**TOWN OF PALM BEACH**  
Planning, Zoning & Building Department  
360 South County Road  
Palm Beach, FL 33480  
(561) 838-5431 • [www.townofpalmbeach.com](http://www.townofpalmbeach.com)

**PZ&B Staff Combination Memorandum: Landmarks Preservation Commission and Town Council**

**SUBJECT:** COA-24-0030 (ZON-24-0078) 448 N LAKE WAY (COMBO)

**MEETING:** JANUARY 22, 2025, LPC  
FEBRUARY 12, 2025, TC

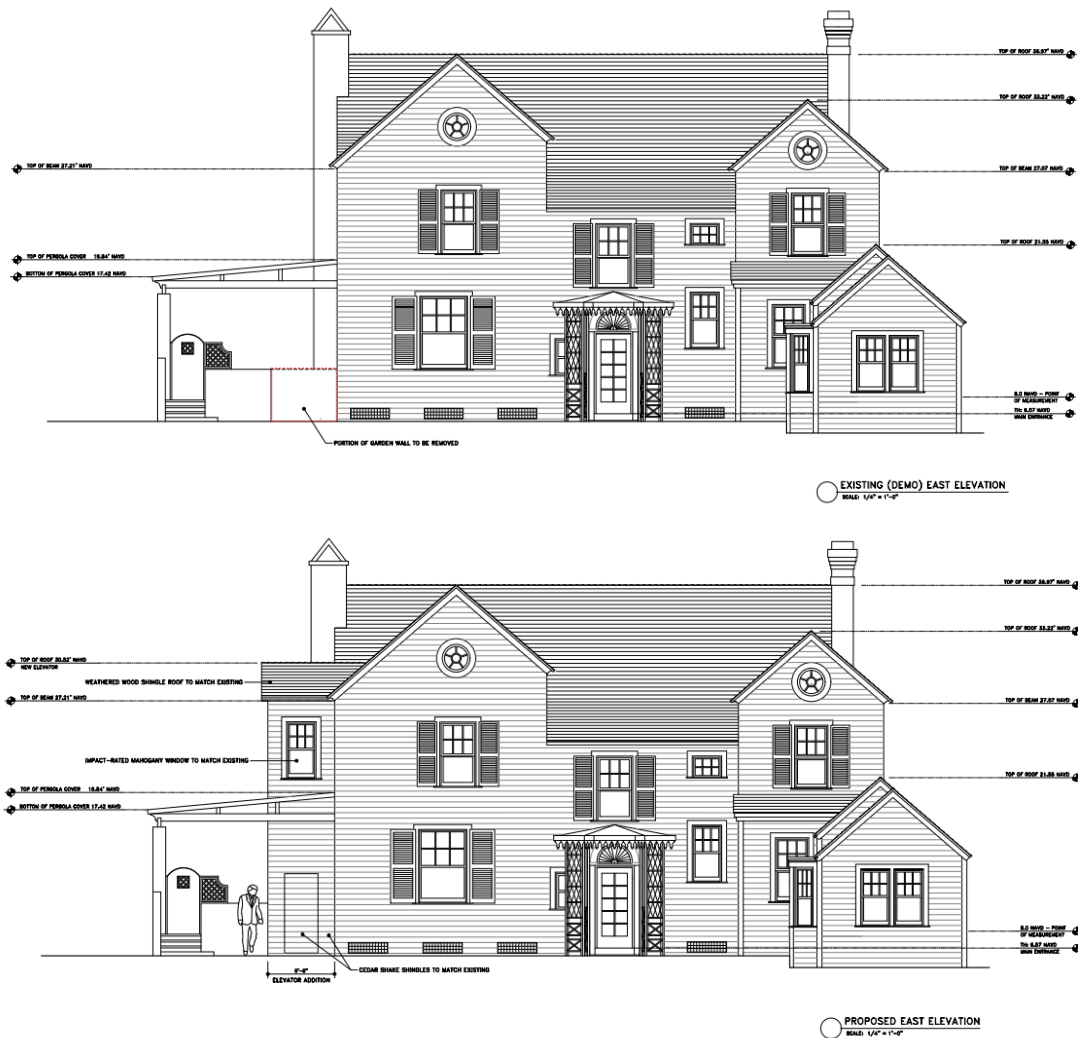
The following variances are required to achieve the additions.

- **VARIANCE #1:** A variance to reduce the side (south) yard setback for the first floor to 10.2', in lieu of the minimum of 12.5'.
- **VARIANCE #2:** A variance to reduce the side (south) yard setback for the first floor to 10.2', in lieu of the minimum of 15'.
